Model Series 463 AMG: Active Distance Assist and
Active Brake Assist IC Message and DTC U0416FE

Topic number	LI54.71-P-078112
Version	6
Function group	54.71 - Camera and radar-assisted assistance systems
Date	10/29/25
Validity	463 AMG
Reason for change	Updating parts.

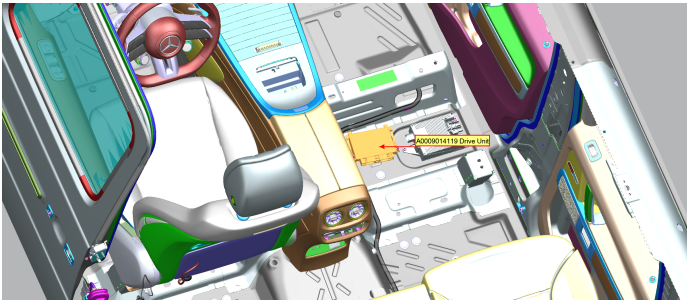
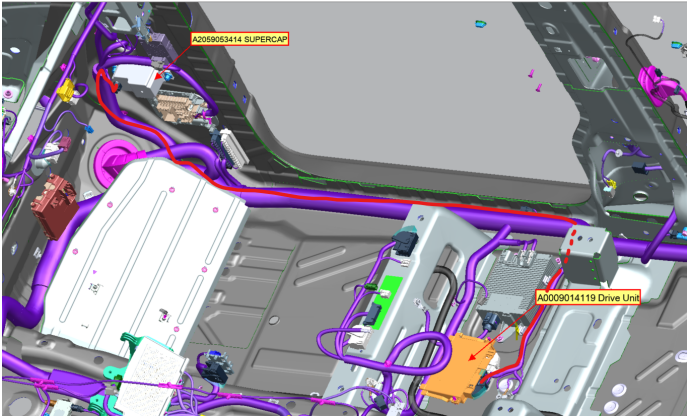
Missing wire between Drive Unit (N145) and Supercap (C8).

Professionally create a new connection by:

- Using a red/white cable with cross-section 0.35 mm² and overall length of approximately 2m.
- Connect Drive Unit (N145) plug A pin 18 to the 3-pin plug of the Supercap (C8) terminal 15 pin 2. Reference the new wire routing location as shown by the red line in "Picture 1 - Connection from Supercap to Drive Unit".
- The new wire should be added to the existing wiring harness as shown by the red line "Picture 1 - Connection from Supercap to Drive Unit".
- Z-Splice is the preferred method using A 000 982 91 10 for the Supercap (C8) connection.
